PROPOSAL FOR DRAFT AMENDMENTS TO REGULATION No. 100

UNIFORM PROVISIONS CONCERNING THE APPROVAL OF VEHICLES WITH REGARD TO PROTECTION AGAINST ELECTRIC SHOCK AND OF BATTERY ELECTRIC VEHICLES WITH REGARD TO SPECIFIC REQUIREMENTS FOR THE CONSTRUCTION, FUNCTIONAL SAFETY AND HYDROGEN EMISSIONS

Annex 4 - MEASUREMENT OF THE INSULATION RESISTANCE OF A VOLTAGE CLASS B BATTERY USING ~~THE TRACTION BATTERY~~ ITS OWN VOLTAGE

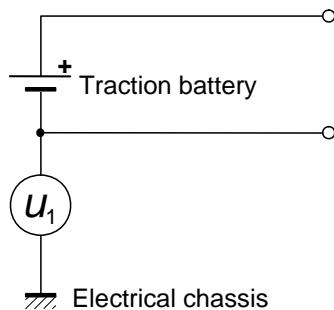
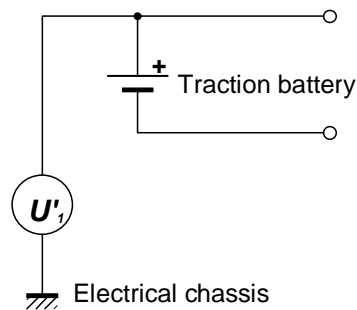
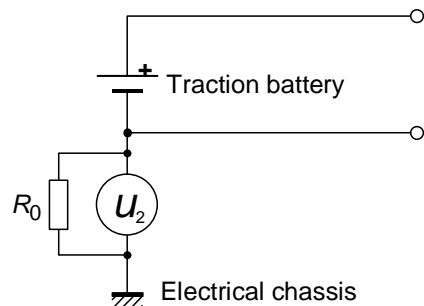
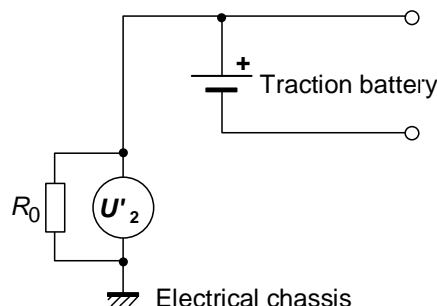
~~The traction battery shall be fully charged.~~

The voltmeter used in this test shall measure DC values and have an internal resistance greater than 10 M Ω .

Throughout the test, the traction battery shall have an open circuit voltage greater than or equal to its nominal value.
